**Re: GE-Pittsfield/Housatonic River Site
Rest of River (GEC850)
Response to EPA's Interim Comments on Corrective Measures Study Report**

**Response to EPA's Interim Comments on CMS Report
Housatonic River – Rest of River**

Volume 1 – Text, Tables, and Figures

March 2009

Figure GC4-1. Sediment alternatives, tonnes CO₂-eq emitted vs. volume of sediments removed.

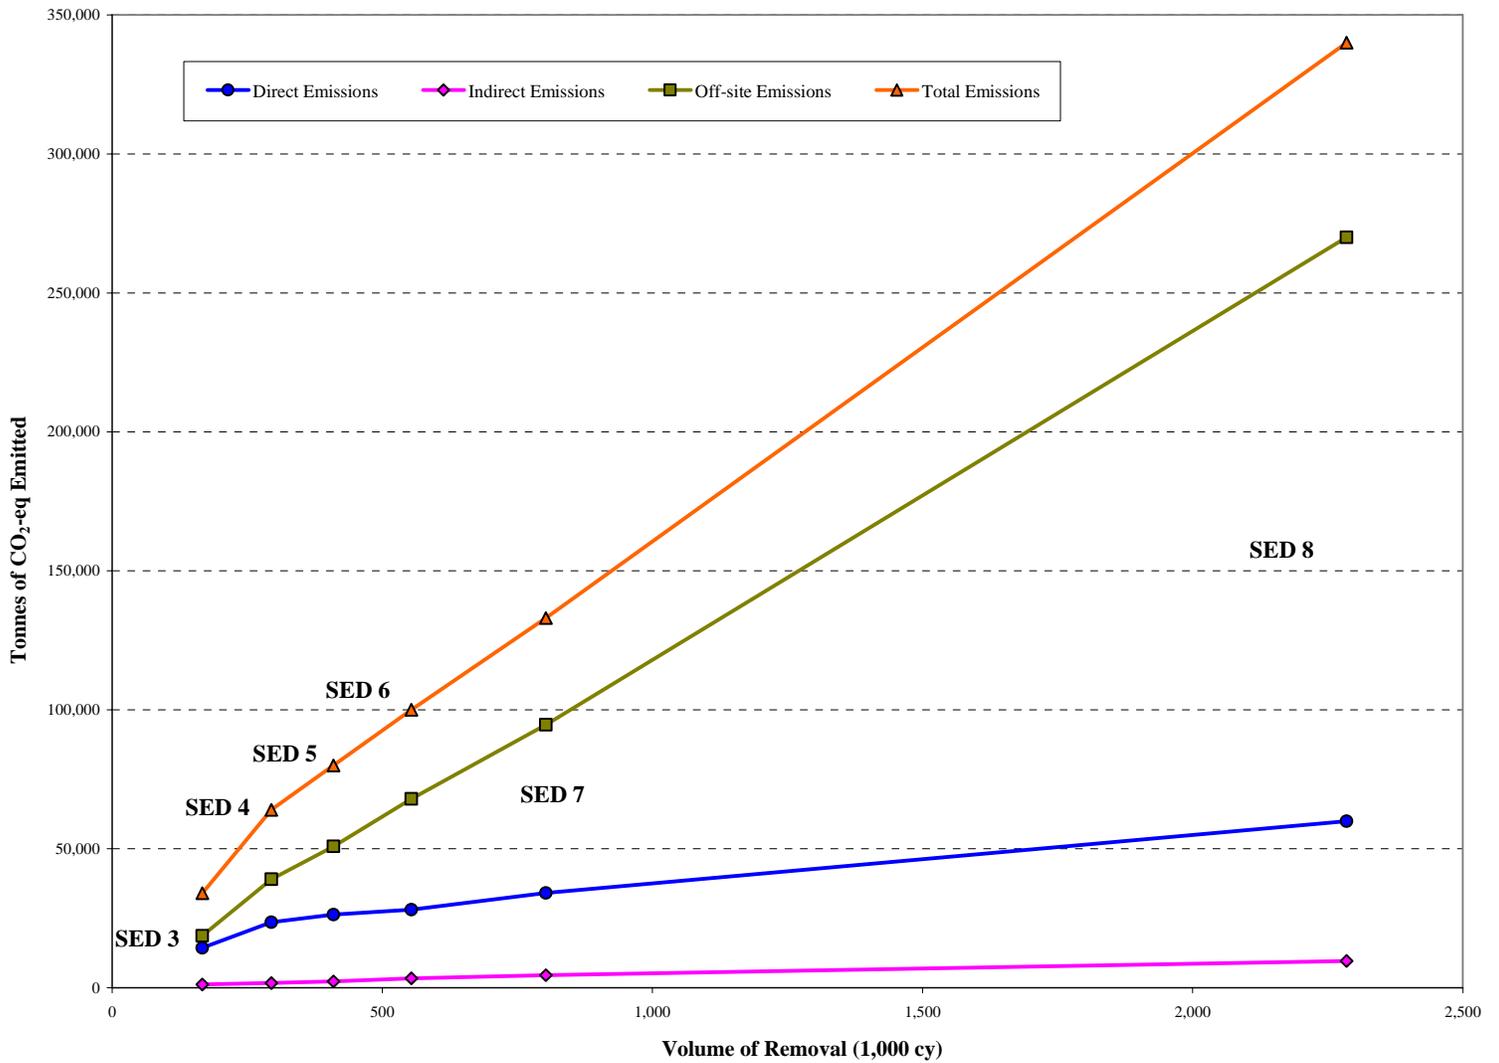
General Comment 4 (Page 2): *GE shall develop and submit the carbon footprint for each alternative being evaluated, including associated transportation, as a measure of short term effectiveness.*

GE Response: As requested, GE has developed an estimate for the carbon footprint of each alternative evaluated in the CMS. Appendix A to this Interim Response contains a greenhouse gas (GHG) inventory/carbon footprint analysis that estimates emissions associated with each of the different sediment, floodplain soil, and treatment/disposition alternatives. This carbon footprint was based on carbon dioxide (CO₂), methane (CH₄), and nitrous oxide (N₂O) emissions anticipated to result from activities supporting each remediation alternative described in the CMS Report. This analysis was conducted in accordance with the Climate Leaders Greenhouse Gas Inventory Protocol, titled *Design Principles*, published by EPA (2005a). In accordance with that guidance, overall emissions for each alternative have been reported as metric tons (tonnes) of carbon dioxide equivalents (CO₂.eq).
